June 13, 2014

RE: Municipal Solid Waste – Webb County
Pescadito Environmental Resource Center (MSW 2374)
Revisions to Parts I and II

MSW PERMIT NO. 2374

**PESCADITO ENVIRONMENTAL
RESOURCE CENTER**

FIGURE 5 - PART 2
MONITORING SYSTEM AND CELL LAYOUT PLAN

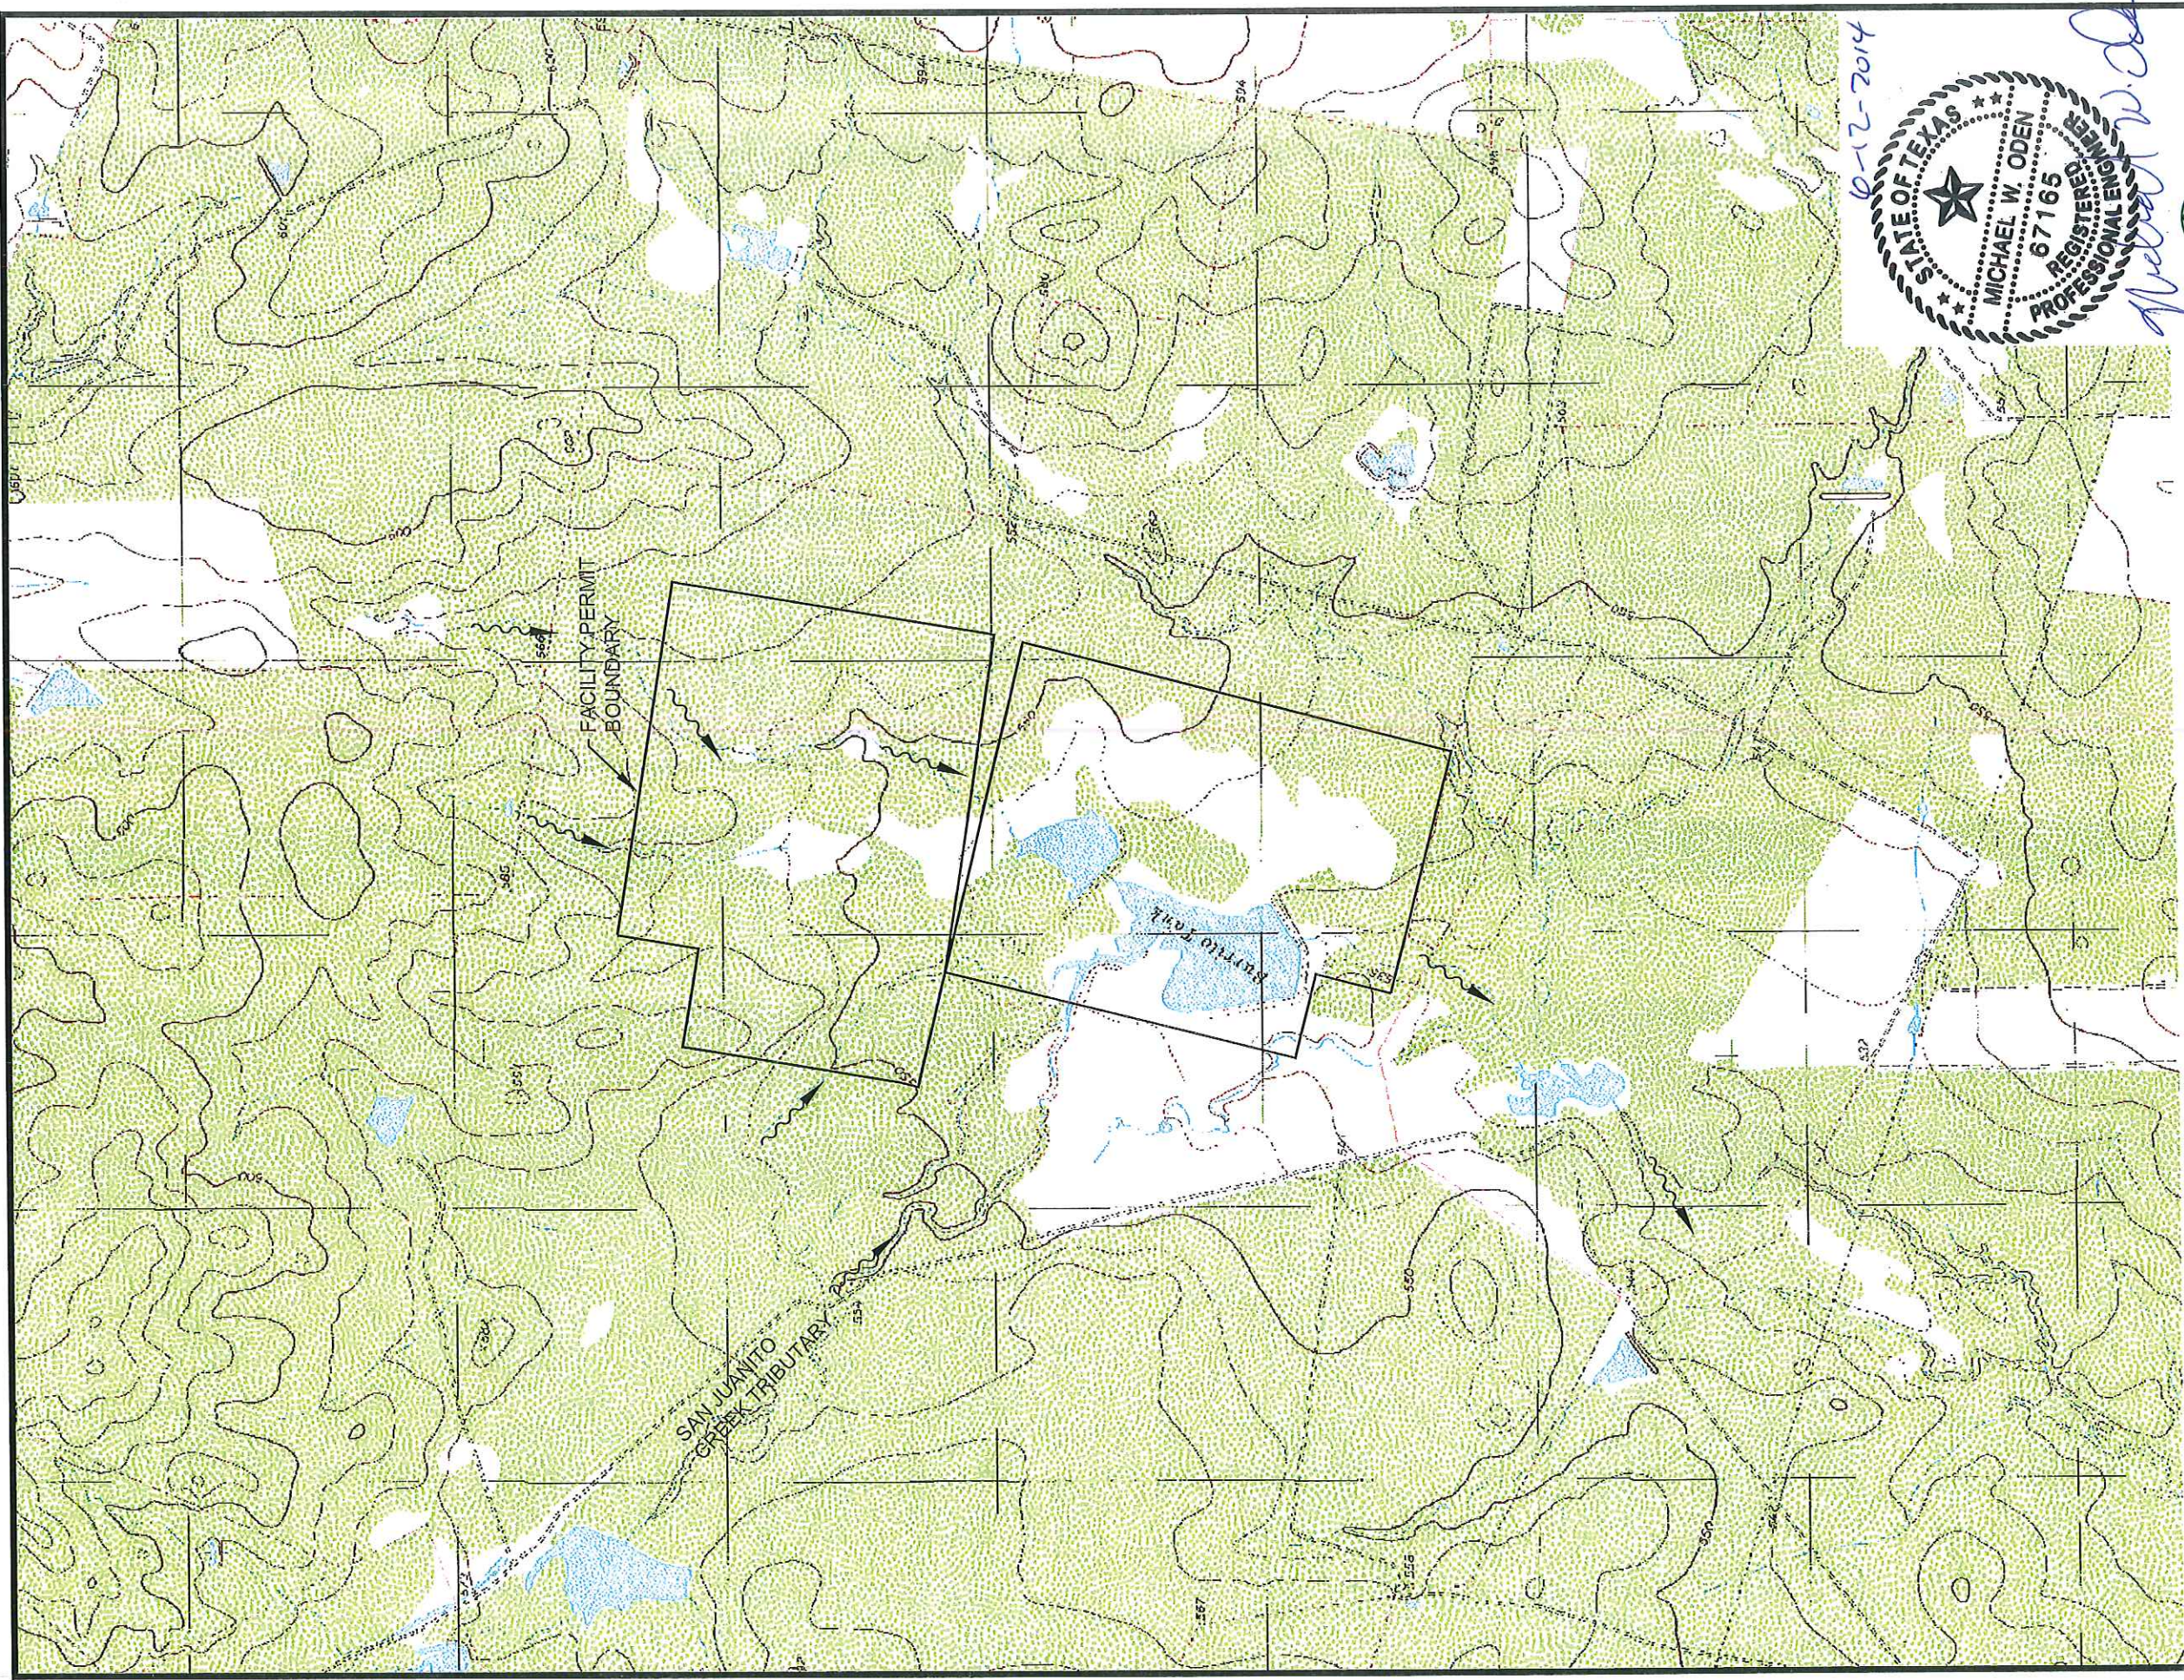
REV. 1 5/22/14 - REVISED FACILITY PERMIT BOUNDARY

**FIGURE 9 - PART II
SUPPLEMENTAL LAND USE MAP**

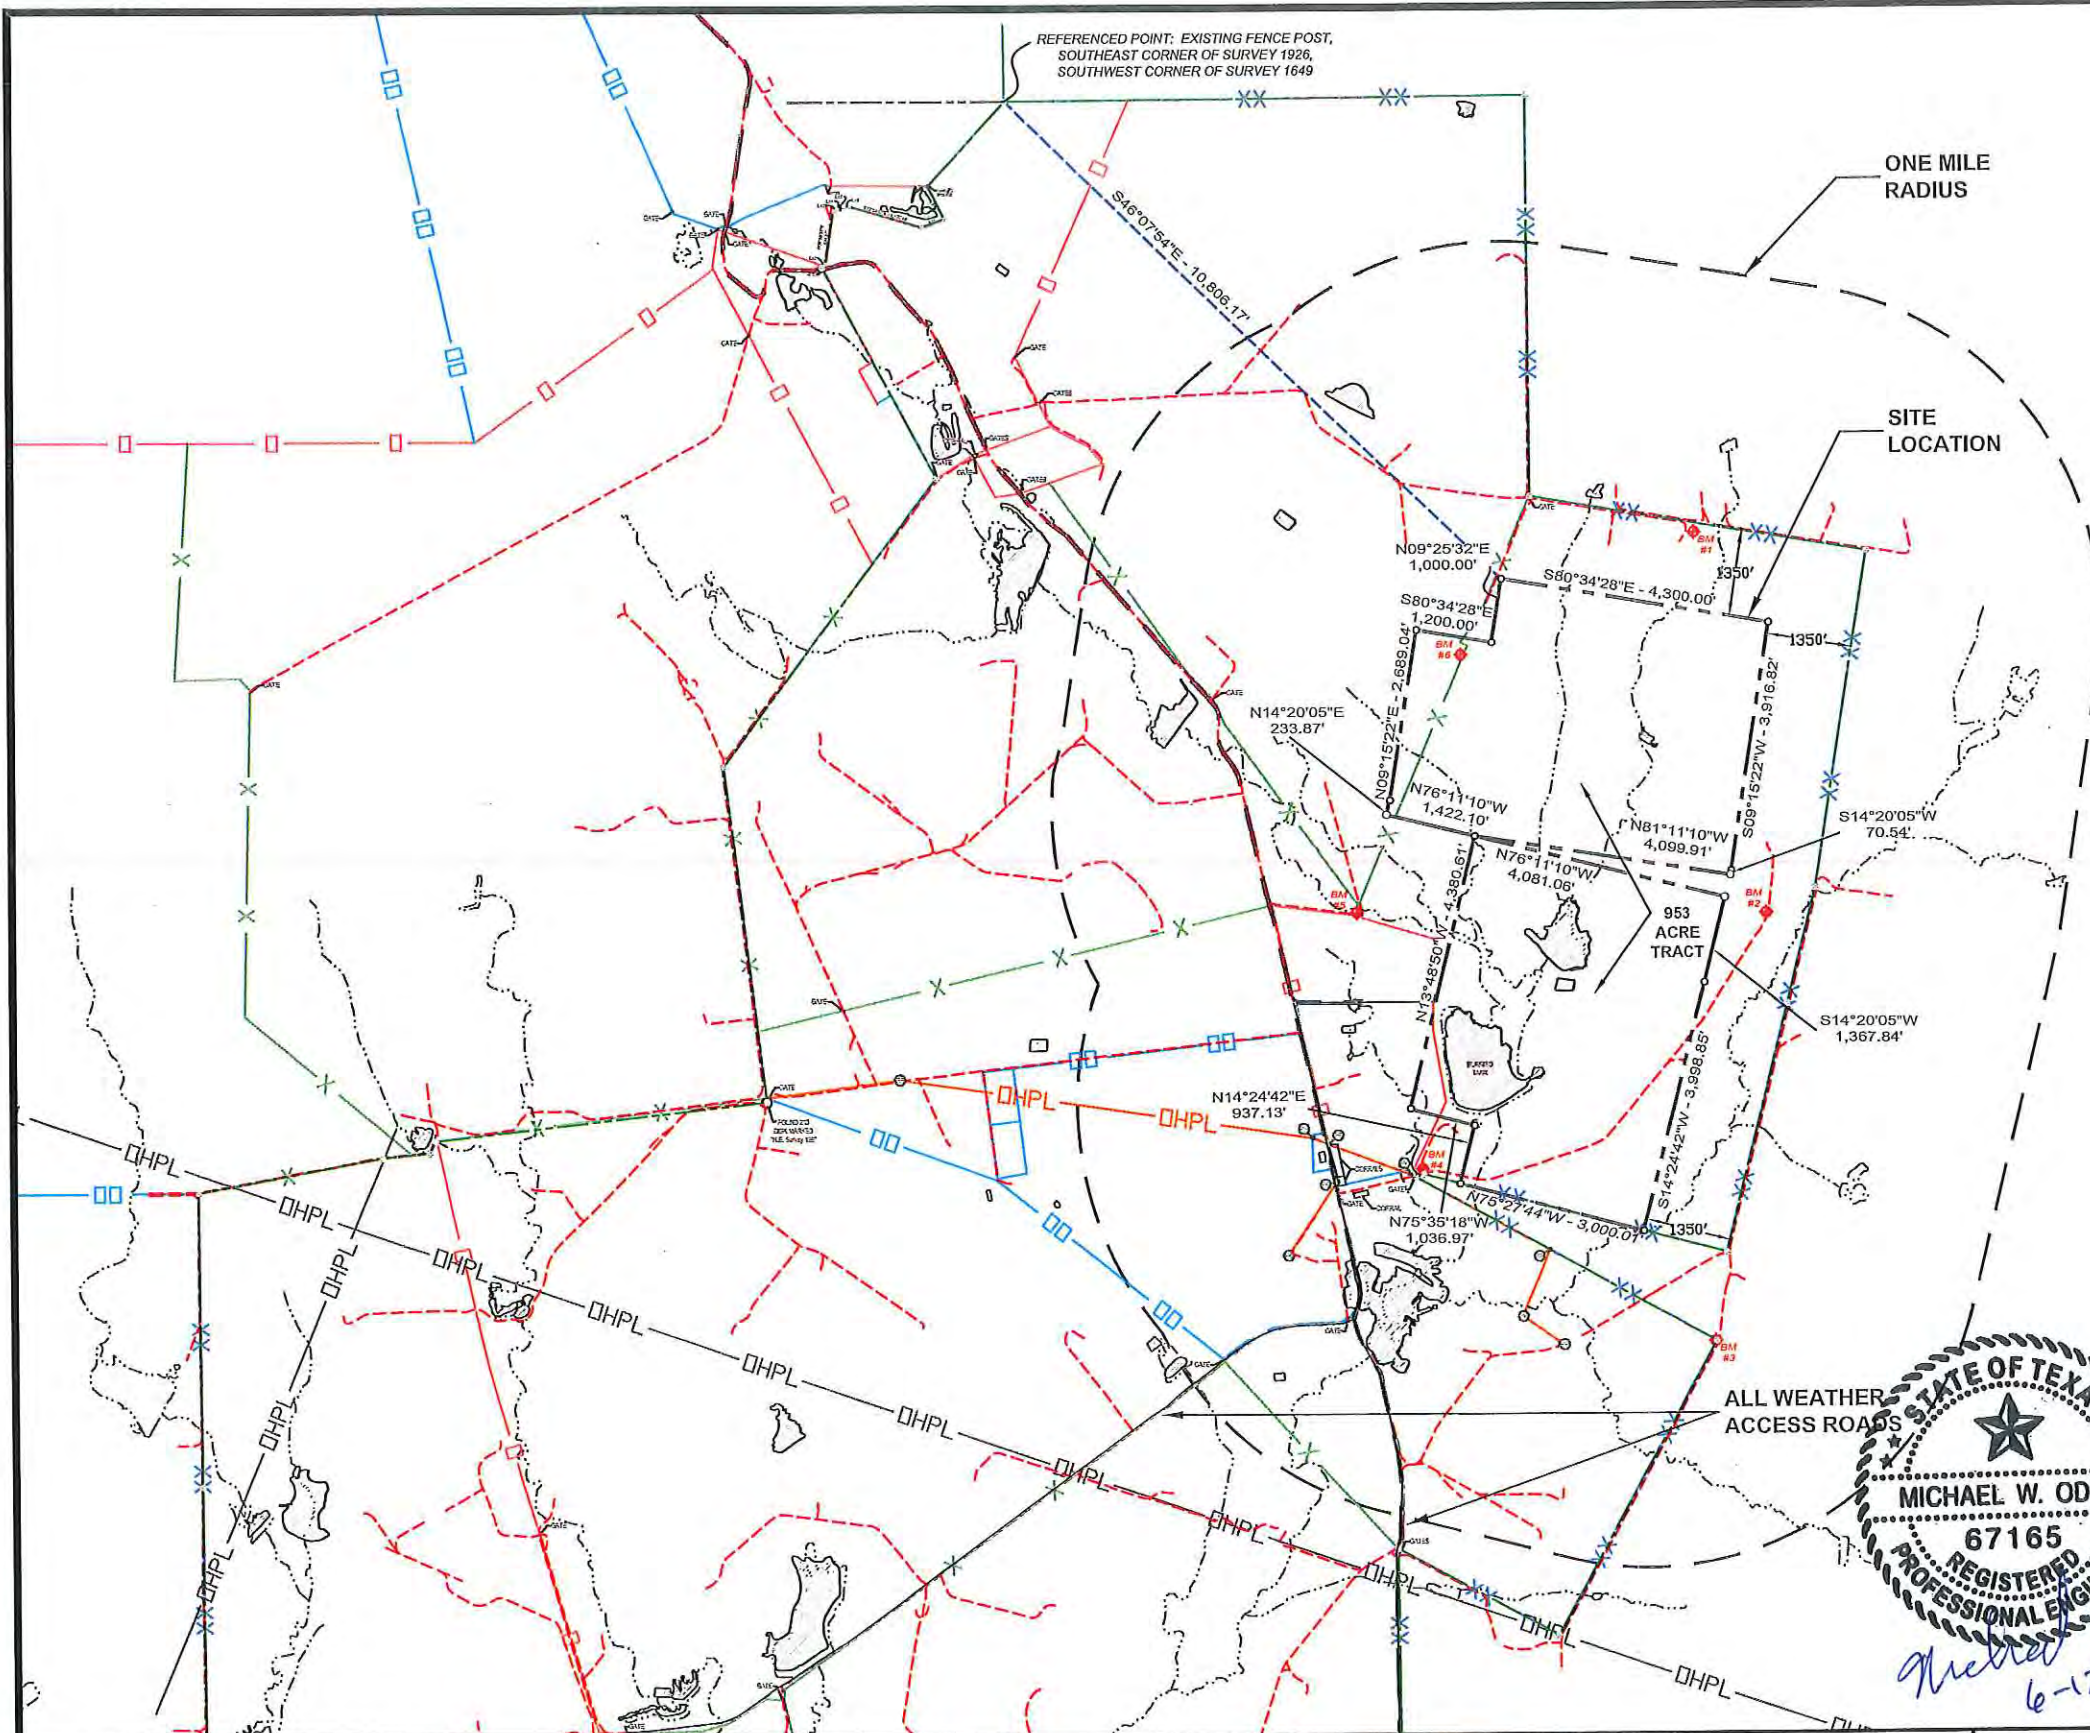
1	5/22/2014	REVISED FACILITY PERMIT BOUNDARY
REV. NO.	DATE	DESCRIPTION
